3 FLAGSTONE DRIVE

STAFF REPORT #2

March 23, 2022

**Re: Town of Hudson Planning Board Review
3 Flagstone Drive Site Plan, 3 Flagstone Drive
Tax Map 222 Lot 14; Acct. #1350-990
Reference No. 20030249.2120**

SHEET NUMBER:
C-301

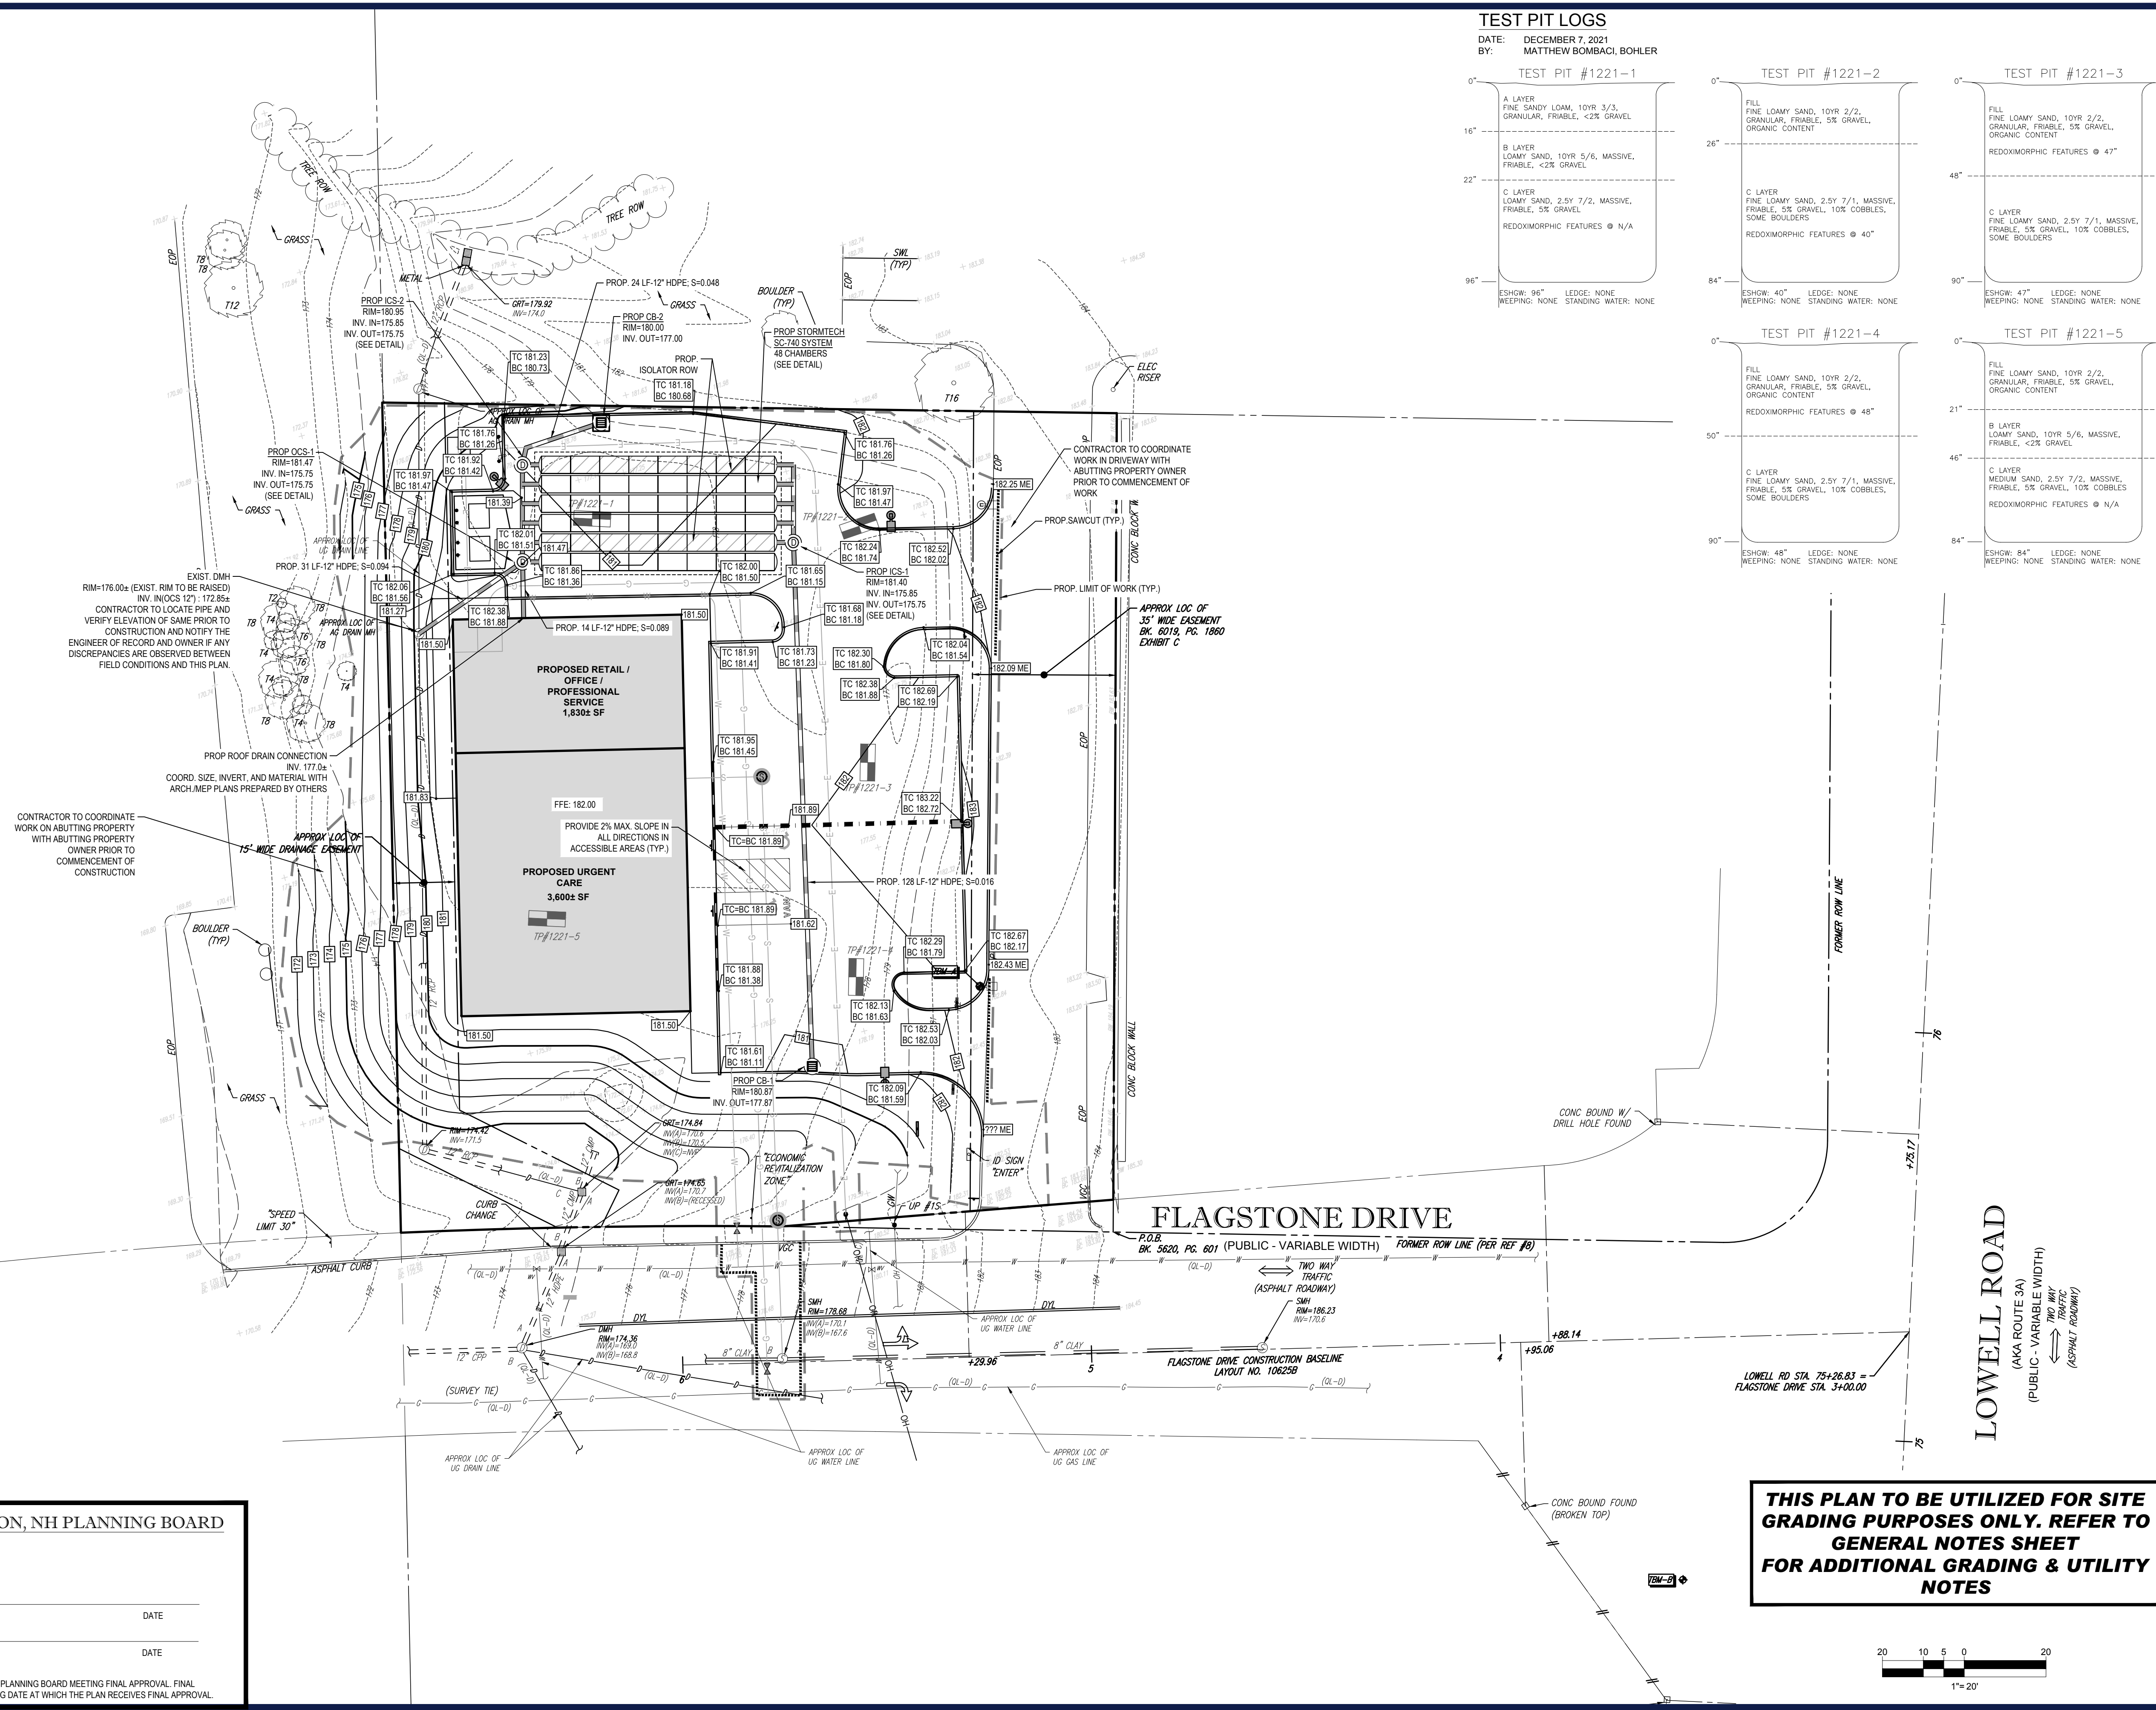
Comment #c. It appears that the arrow for the snow storage area note should be pointing to the nearby clouded area, not the general lawn area, on sheet C-301.

Response: The notation arrow for the proposed snow storage area has been realigned, as shown on Sheet C-301 of the enclosed updated Proposed Site Plan Documents.

SHEET NUMBER:
C-501

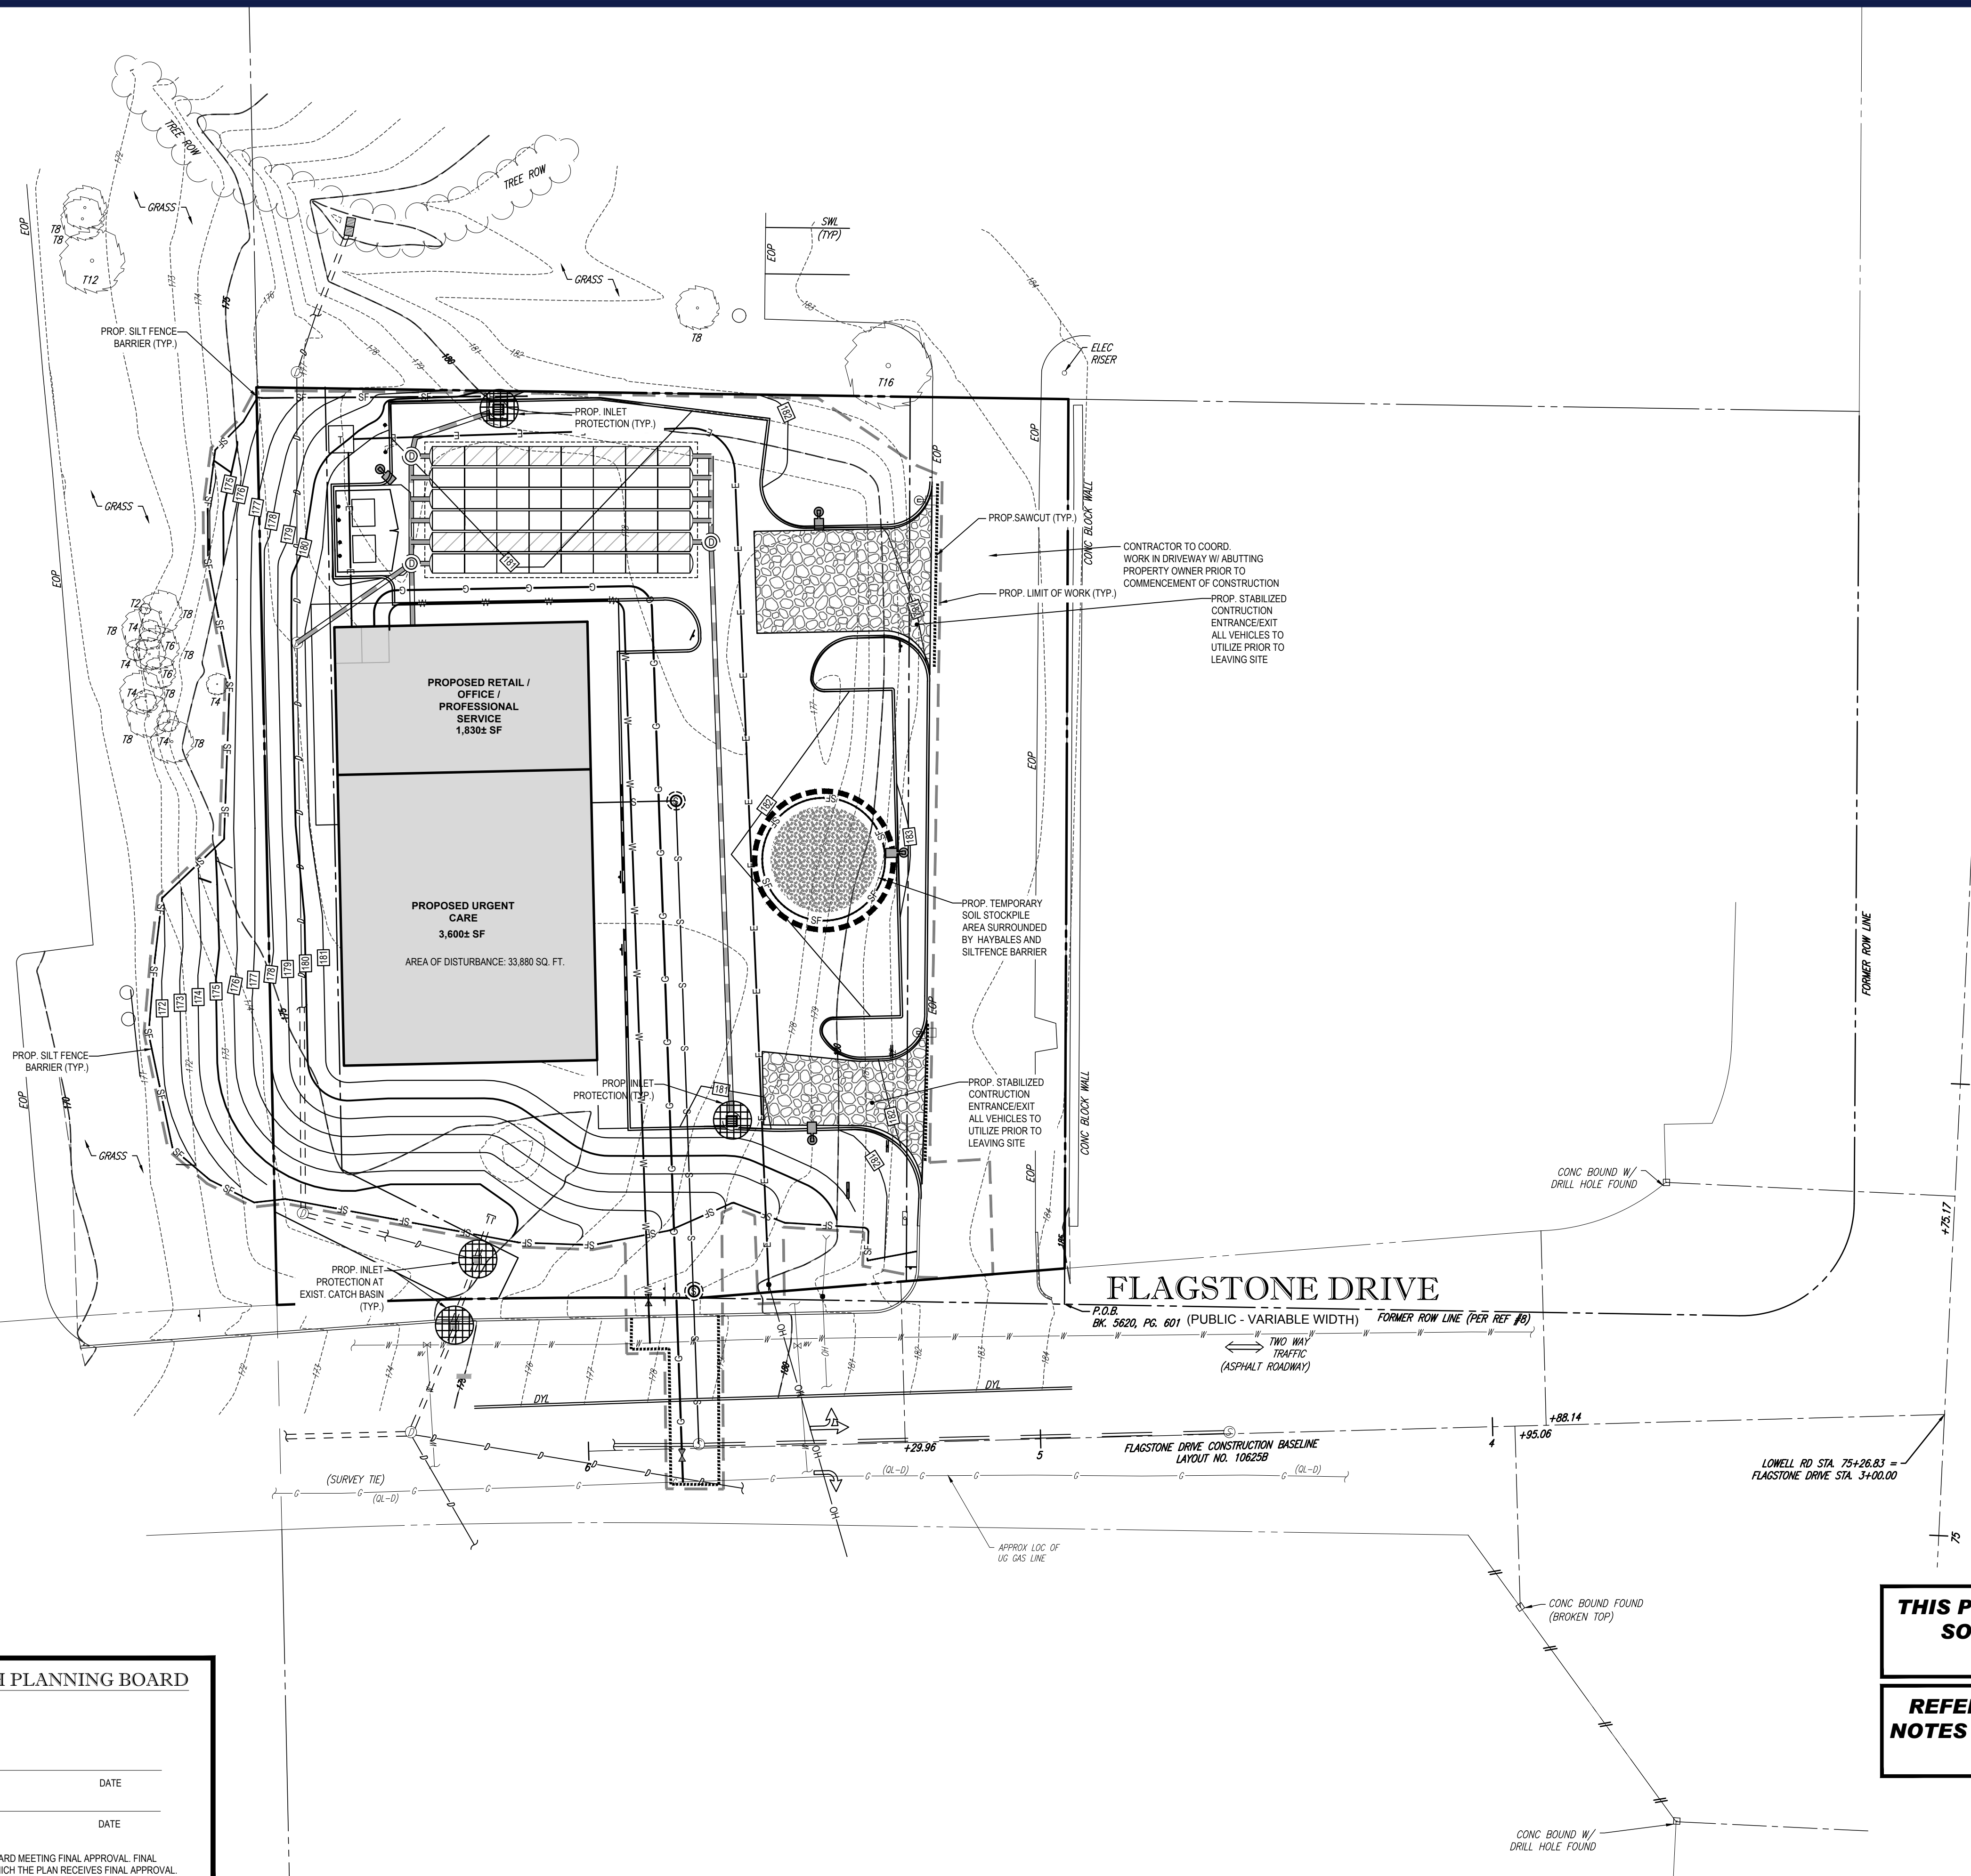
Comment #b. ETGTD Section 720.8.3. The applicant has not provided a clean out for the proposed sewer service. This should be located at the property line.

Response: **A proposed sewer manhole has been added at the property line, as shown on sheet C-501 of the enclosed Proposed Site Plan Documents.**

SIGHT DISTANCE INSET INTERNAL DRIVEWAYS

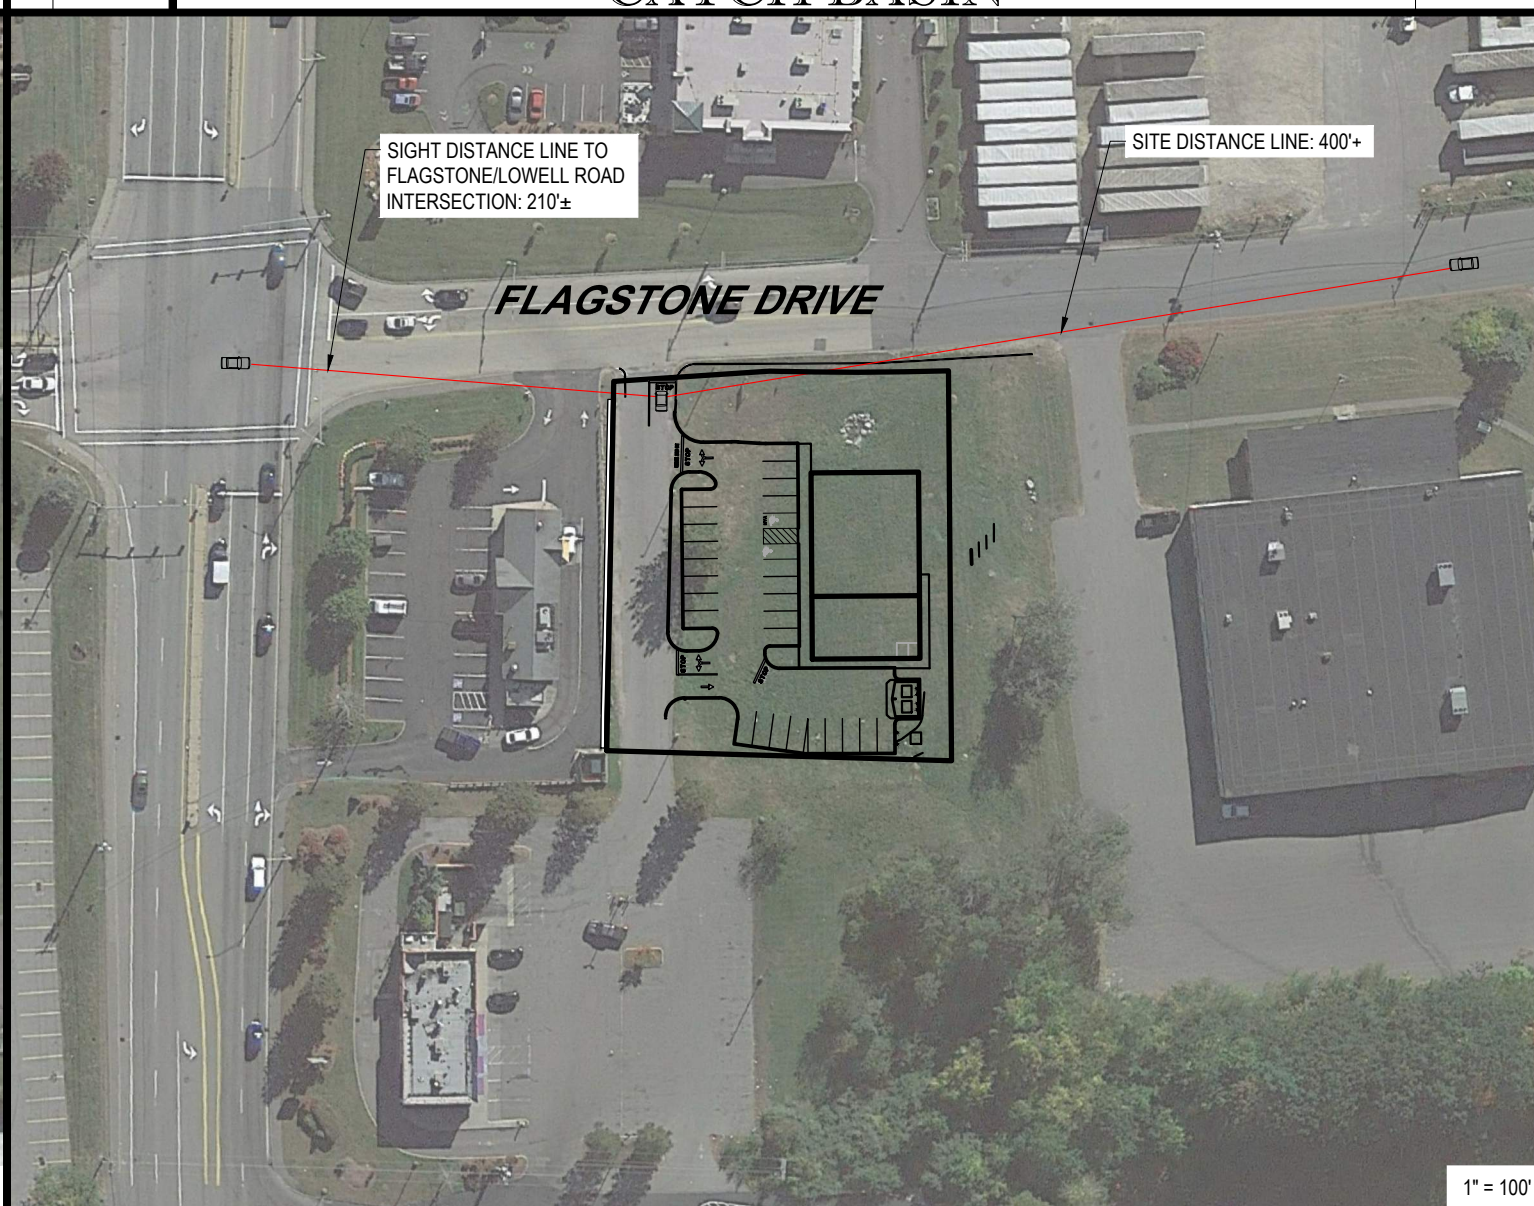
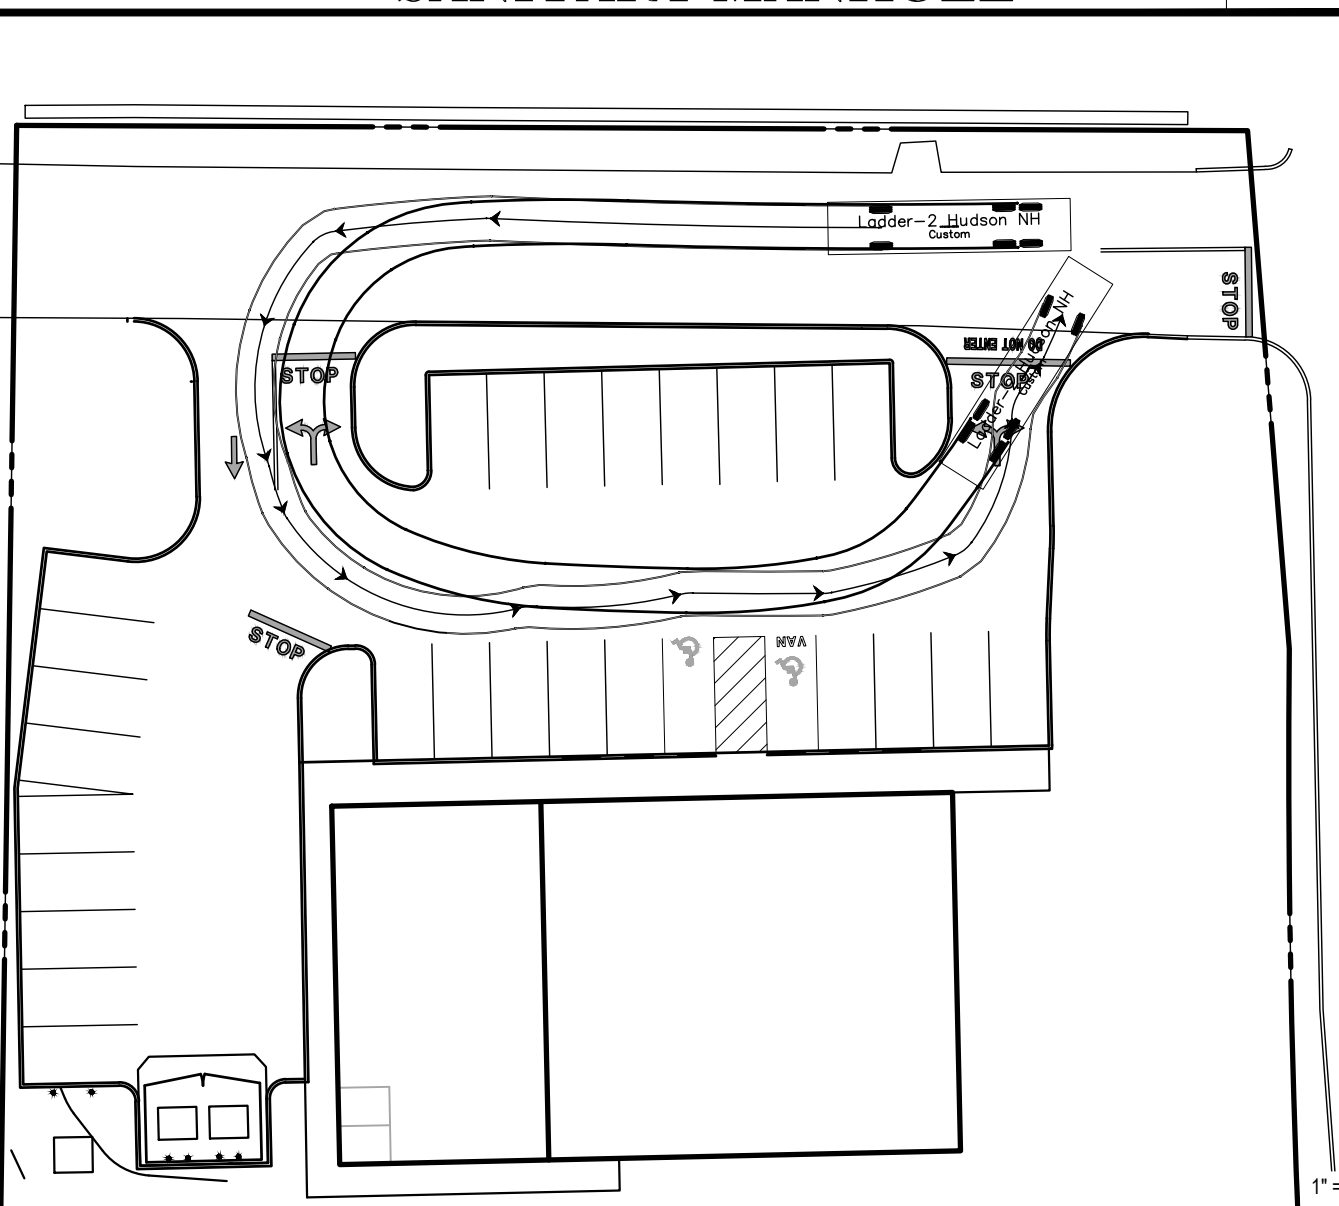
Comment #b. HR 193.10.E. The applicant has not provided any sight distances for the proposed driveway location on the plan set. We note that the site is planning to tie into the existing driveway located within an easement on the site.

Response: As noted, the project proposes to utilize the existing driveway connection to Flagstone Drive. Sight Distance Insets reflective of the sight distance lines associated with same have been added to sheet C-902 of the enclosed Proposed Site Plan Documents.
